## City of Portland, Me.

REASON FOR PERMIT: Amendment - Add 2 decks and Altin elevation with Daylight Basement in Rear

REASON FOR PERMIT: Amend # 001189 add 2 deck / 1011 Elev daylight base

CITY OF PORTLAND, ME  
 BOCA 1999 Plan Review Record  
 One and Two Family Dwelling

REAR ELEVATION

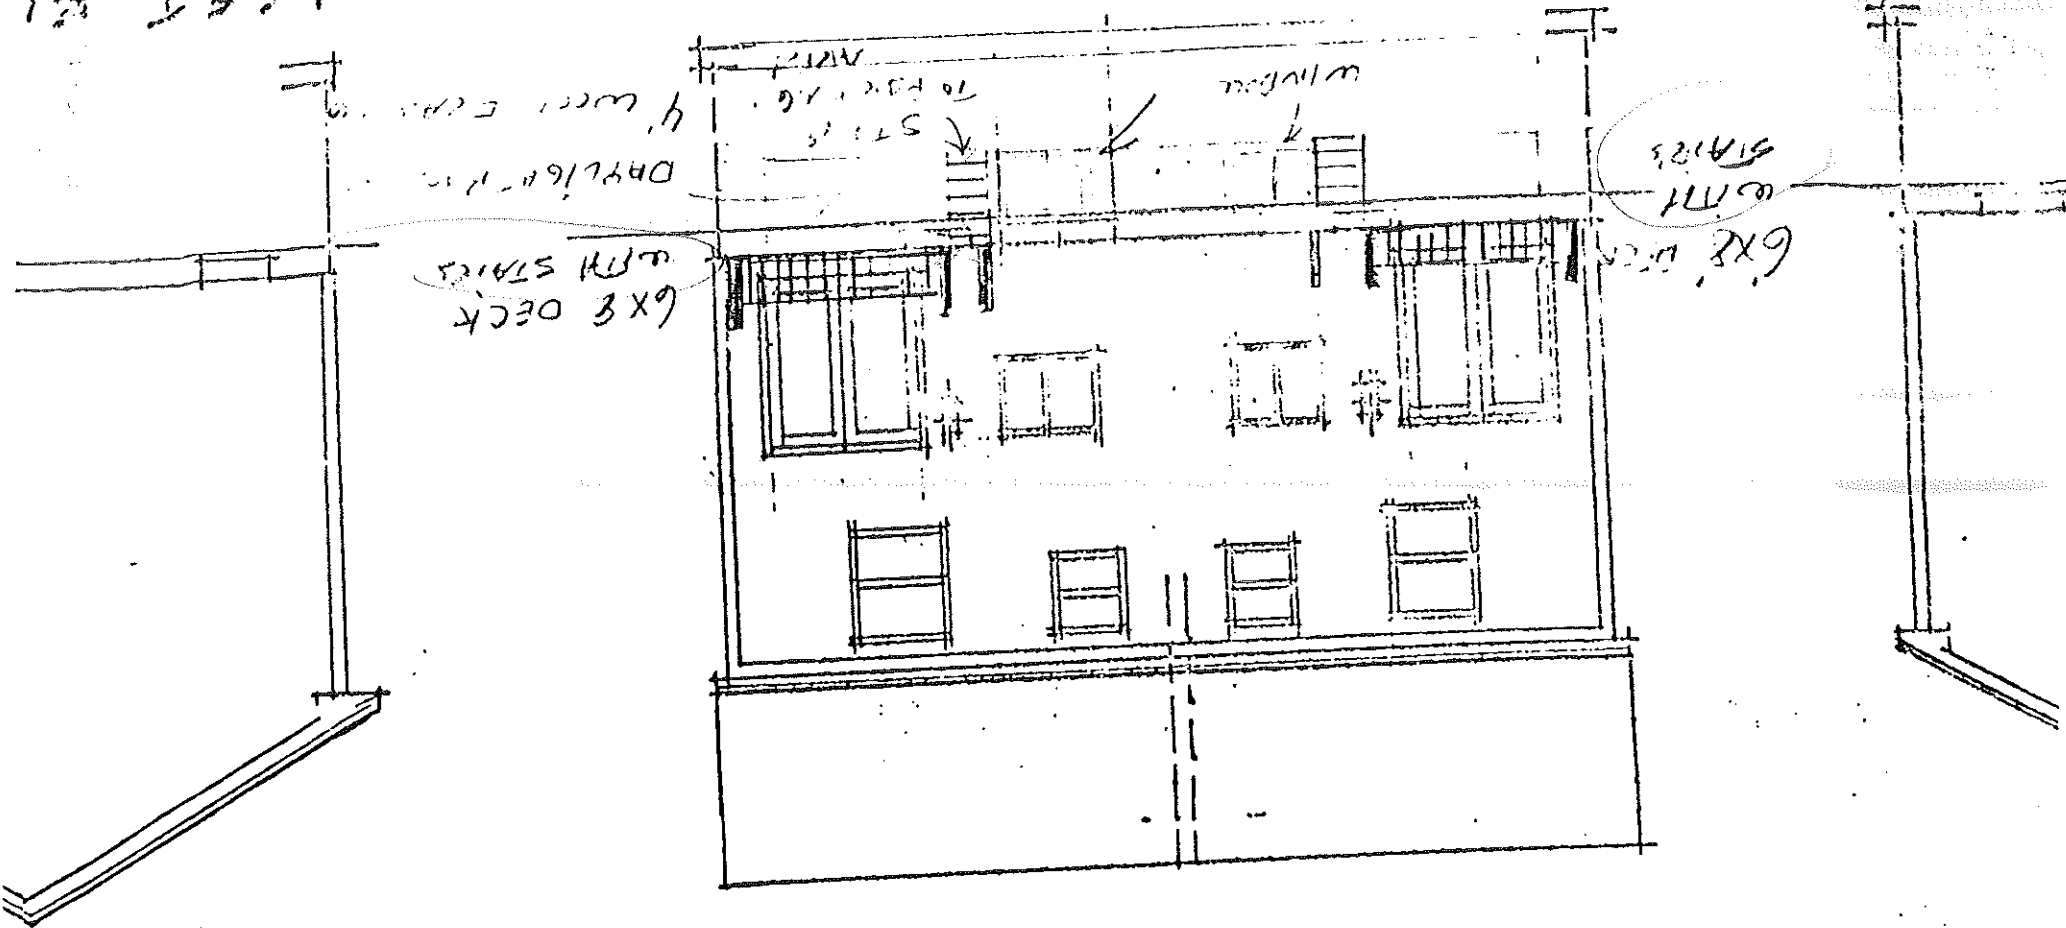
Daylight Basement  
Does not appear  
more original plans

See Annual  
Stair grade changes

# REAR ELEVATION

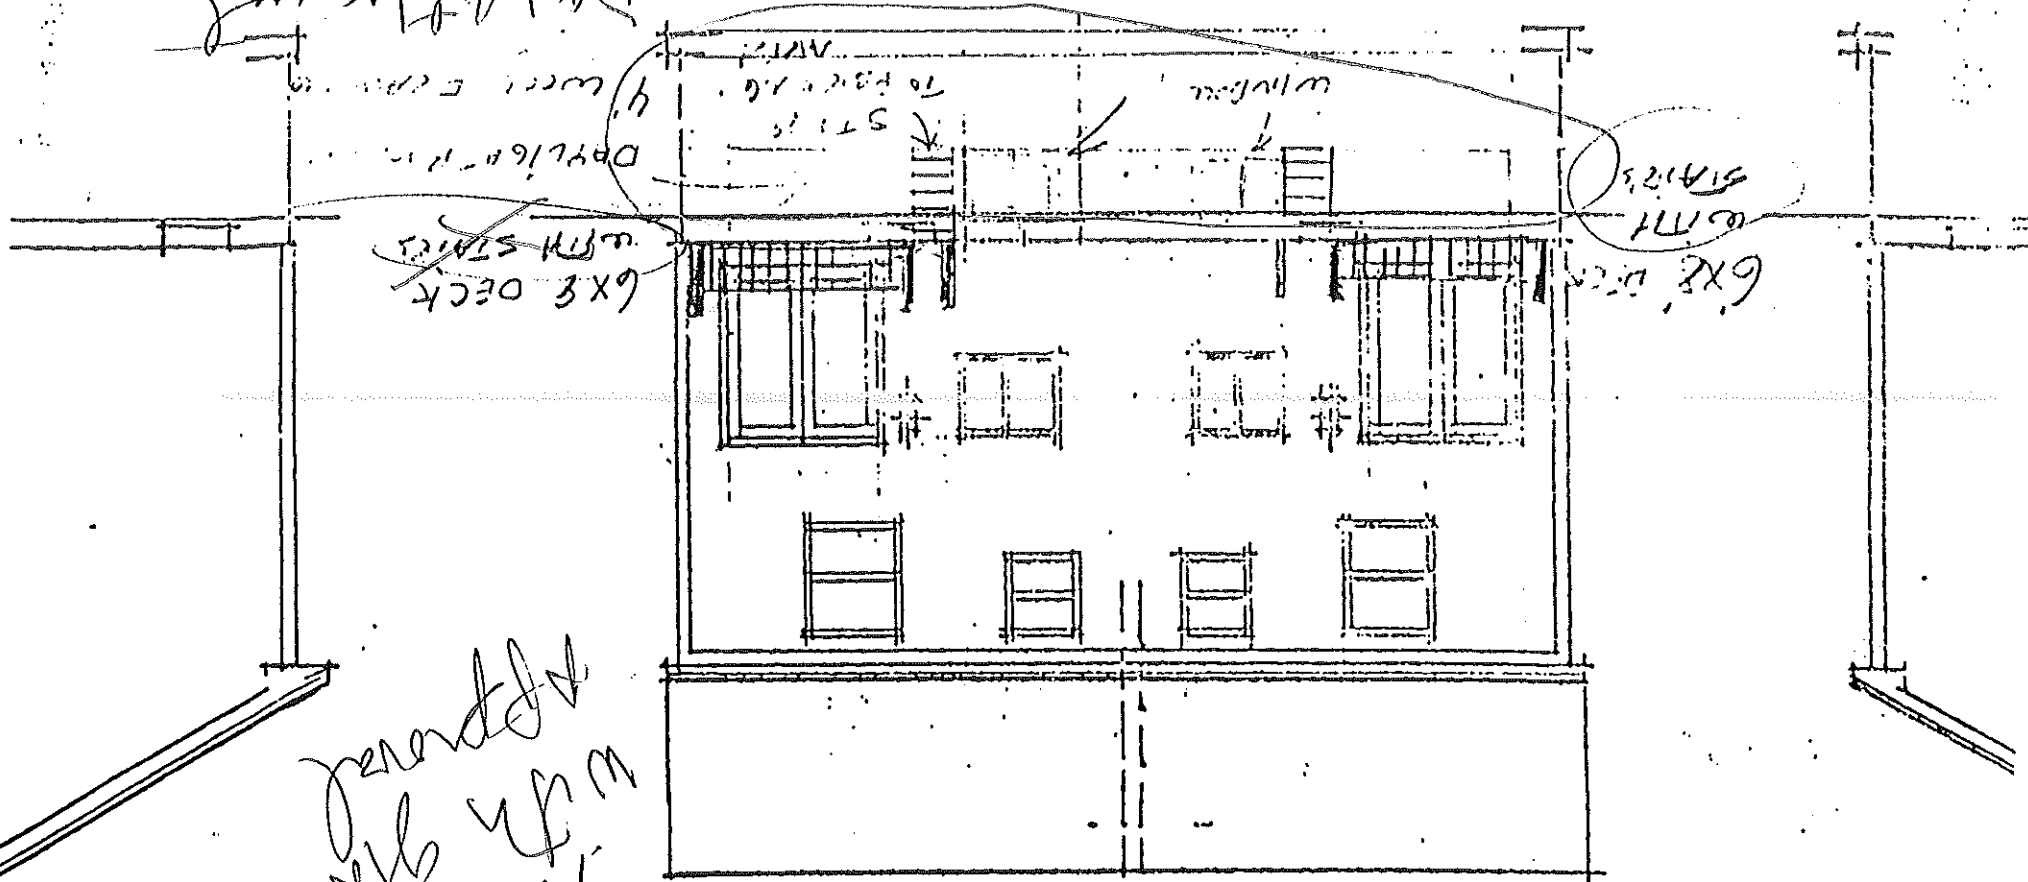
Design of Basement  
was not approved  
in the original plans

See other  
received 12/13/08  
with approval  
with grade change

Job	Truss	Truss Type	Qty	Fly	Y1521448
R48417	A	COMMON	16	1	
SPROWL BUILDING COMPONENTS, SEARSMONT, ME. 04973					
4.201 SR1's Sep 5 2000 MITEK Industries, Inc. Tue Feb 05 17:54:14 2007 Page 1

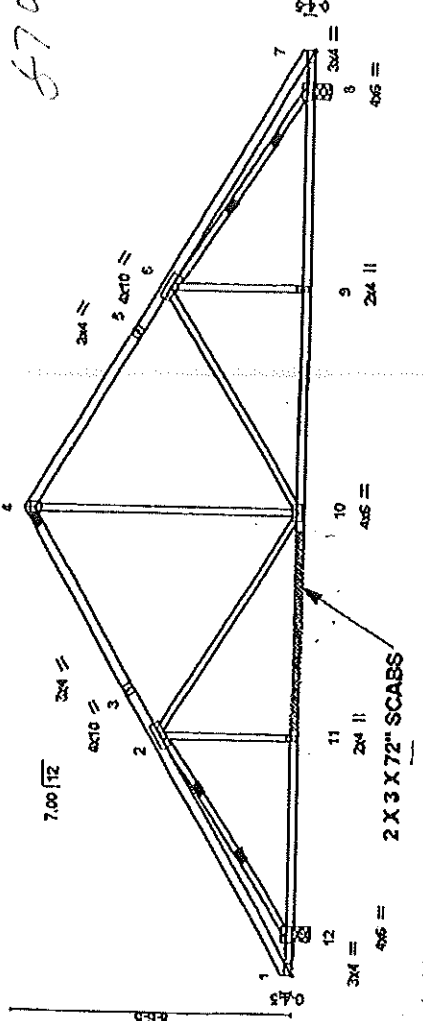
CONDITION: BOTTOM CHORD HAS A 10" LONG CRACK LOCATED 10-0-0 FROM LEFT END OF TRUSS. ATTACH SCABS.

APPLY SPF 1650 SCAB(S), ONE EACH FACE, AS SHOWN. SECURE SCAB(S) USING CONSTRUCTION QUALITY ADHESIVE AND 10d COMMON WIRE NAILS (131" DIA. X 3") 2 X 3'S - 2 ROWS @ 5.0" O.C.

STAGGER NAIL SPACING FROM FRONT FACE AND BACK FACE.
